REDBUD LANE
FORCE MAIN EXTENSION

REDBUD LANE - FORCE MAIN EXTENSION

UTILITY PLAN

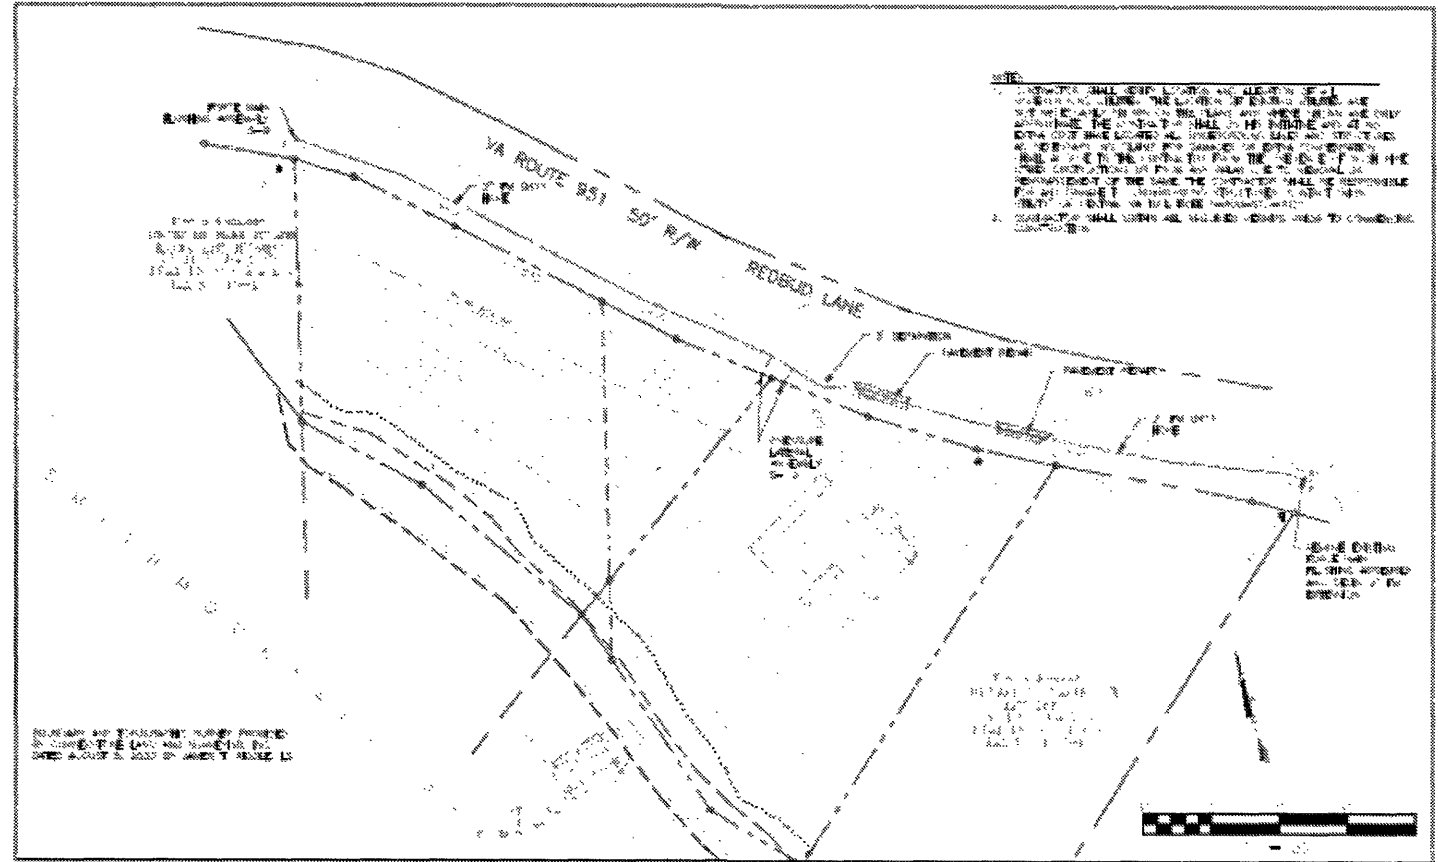
Change 1: eliminate the first lateral assembly that was initially going to support 979 Redbud Lane but they already have a working septic system. We will maintain the lateral supporting our lot.

Change 2: Aaron at WVWA has agreed to move the overall extension back to the 3+00 line and we will install the flushing assembly there as notes by the highlighted line below.
